Access Compliance Report

Public Rights-of-Way

(Curb Ramps)

Intersection ID: 7850	Main Street: MUNSEE_ST	Cross Street: YUMA_ST	Location: NE
ADA ID: BCE029BEA5D3	Ramp Type: Para	Initial Pass/Fail: Fail	Overall Compliance: No
			Severity Score: 25

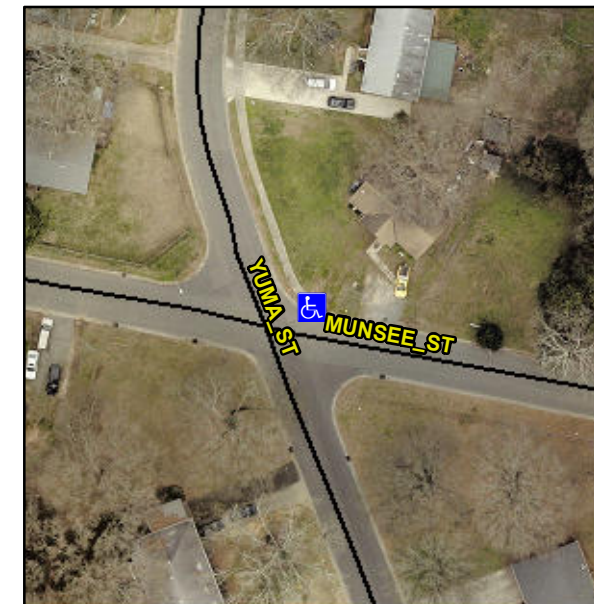
RT RP < 5%, NO RT SW

R304.3.2

Compliance	Description	Data	Compliance	Description	Data
N/A	Ramp Length LT (in)	27.0	N/A	Ramp Length RT (in)	26.5
Yes	Ramp Width LT (in)	60.0	Yes	Ramp Width RT (in)	72.0
No	Ramp Slope LT (%)	12.7	Yes	Ramp Slope RT (%)	0.2
Yes	Ramp XSlope LT (%)	1.8	Yes	Ramp XSlope RT (%)	1.8
N/A	Landing Length (in)	N/A	N/A	DWS Provided?	N/A
N/A	Landing Width (in)	N/A	N/A	DWS Contrast?	N/A
N/A	Landing Slope (%)	N/A	N/A	DWS Length (in)	N/A
N/A	Landing X Slope (%)	N/A	N/A	DWS Full Width?	N/A
N/A	Landing Curb? (Y/N)	N/A	N/A	DWS Offset (in)	N/A
N/A	Shared Landing?	N/A			
N/A	Gutter Ponding?	N/A	N/A	Gutter Slope (%)	N/A
N/A	Gutter Lip Ht (in)	1.5	N/A	Gutter X Slope (%)	N/A
N/A	Painted X Walk1?	No	N/A	Painted X Walk2?	N/A
	X Walk 1 Direction	To S		X Walk 2 Direction	N/A
N/A	X Walk 1 Width (in)	N/A	N/A	X Walk 2 Width (in)	N/A
	X Walk 1 Slope (%)	4.3		X Walk 2 Slope (%)	N/A
	X Walk 1 X Slope (%)	3.4		X Walk 2 X Slope (%)	N/A
N/A	Ramp inside XWalk1?	N/A	N/A	Ramp inside XWalk2?	N/A

Remove & Replace Entire Ramp.
